S/UNI-LITE ERRATA NOTICE

SATURN USER NETWORK INTERFACE (LITE)

DATA SHEET ERRATA

ISSUE 9: MARCH 1999

2 BRANDING DIAGRAM

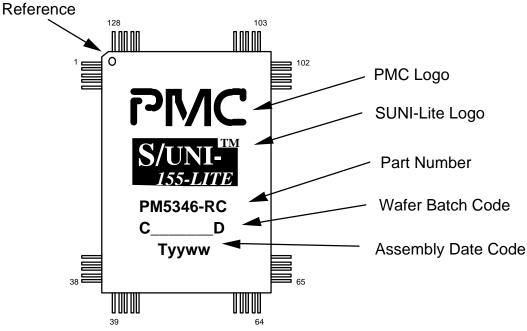
Wafer Batch Code has three components:

- One character for wafer fab source (**P or C**)
- Up to 7 characters and/or digits for wafer manufacturer's batch code
- (_____

• One character for mask set revision (A, C or D). Note: There is no rev. 'B'.

For example "CA123456D" is for source "C" wafers, batch A12345.6, device rev "D"

Assembly Date Code has three components:

- 1 character for assembly source (T)
- 2 digits for year (yy)
- 2 digits for week (ww)

For example "T9524" is for parts packaged by source "T" in the 24th week of 1995.

Fig. 14b Clock Recovery Circuit - Unity Gain Buffer Loop Filter (recommended for designs requiring BISDN-UNI jitter transfer)

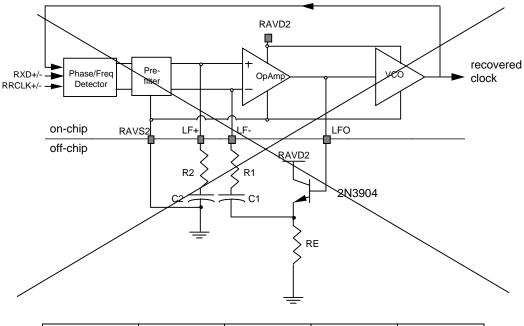
On Page 113 of the Issue 6 datasheet, make the following changes (delete entire page):

The capacitors (C1, C2) determine the amount of "peaking" in the jitter transfer curve. The capacitor values can be $\pm 10\%$. The capacitors should be non-polarized because when the S/UNI-LITE is held in reset, the capacitors are reverse-biased at approximately 2.0V. Also, for some process extremes, the capacitors may operate with a D.C. reverse-bias of up to 1.0V.

The recommended values for the capacitors are not readily available in nonpolarized versions. Therefore, two polarized capacitors can be connected "backto-back" (in series, anode-to-anode) to implement each capacitance in Figure

14b. Since these back-to-back capacitors will be in series, they should be of twice the value of the desired capacitance. This back-to-back configuration effectively creates a "bi-polar" capacitor.
